Work Order ID 97544

Item Name: Passenger Door Opener Installation, RH

DART SERVICE INSTRUCTION

TO AMEND INSTALLATION INSTRUCTIONS IIN-D206-802-3 Rev. A AND
INSTRUCTIONS FOR CONTINUED AIRWORTHINESS ICA-D407-802 REV. 0

FIGURE 1: INSTALLATION OF D206-802-032 ON COMPOSITE AIRFRAME

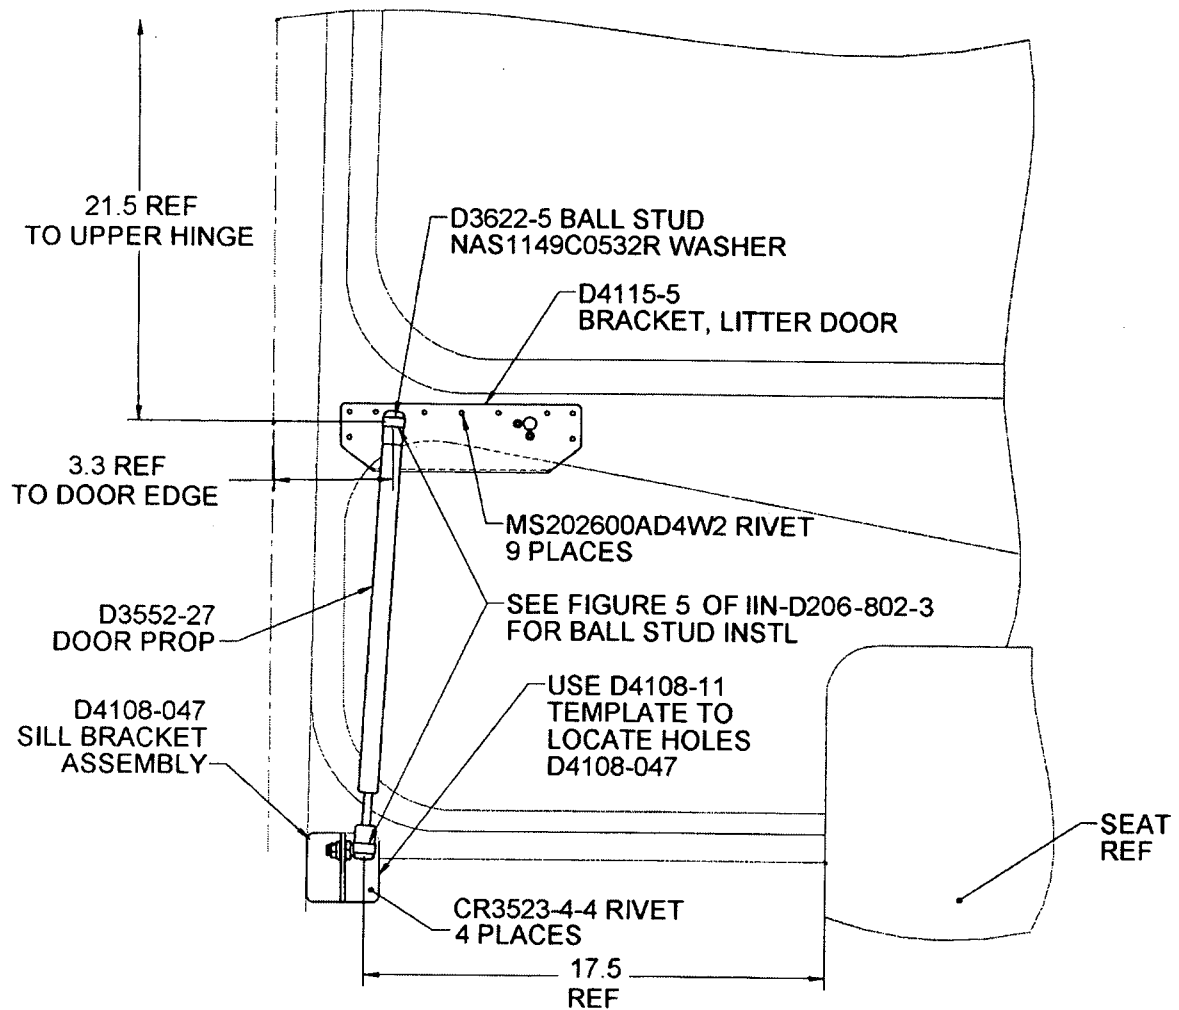
4.2 On composite airframe:

Install D206-802-032 by replacing D4112-1 Aft Sill Doubler with D4108-047 per instructions below and Figure 1 of this Service Instruction.

4.2.2 Replace Steps 3.3.2 to 3.3.16 with the following:

- a) Using Figure 1 of this Service Instruction, locate D4108-11 Template on the edge of the door post closeout approximately 17.5" from the front of the seat. Match drill the $\varnothing 0.128$ " rivet holes (4 PL) on the door sill. Locate and drill thru template and door sill if the door sill is without existing holes.

- b) Transfer drill the $\varnothing 0.128$ " holes (4 PL) from D4108-11 Template to the D4108-047 Sill Bracket Assembly.
- c) Deburr all drilled holes and clean area.

- d) Remove and retain the Ball Stud and hardware from the D4108-047 Sill Bracket Assembly.
- e) Install D4108-047 Sill Bracket Assembly by applying a thin layer of Proseal 890 and wet installing the CR3523-4-4 Rivets (4 PL) as shown in Figure 1 of this Service Instruction.

- f) Remove excess Proseal, grind rivet stems flush and clean area of any debris.
- g) Re-install the Ball Stud and hardware removed at Step "d)" of this instruction.

- h) Re-position the carpet and interior trim panel. Trim/cut as required for the ball stud and to allow the D4108-047 Sill Bracket Assembly to protrude.

- i) Re-install the scuff plate.
- j) Install rod end of D3552-27 Door Prop onto the Ball Stud mounted on D4108-047 Sill Bracket Assembly.
- k) With the door open and using the D3552-27 Door Prop, Figure 4 and the dimensions shown as reference, position D4115-5 Doubler. Ensure that the door opens far enough for ingress and egress (minimum of 19" wide) and that there is no interference with any structure or interior trims. The final location of the D4115-5 Doubler will vary somewhat from aircraft to aircraft.
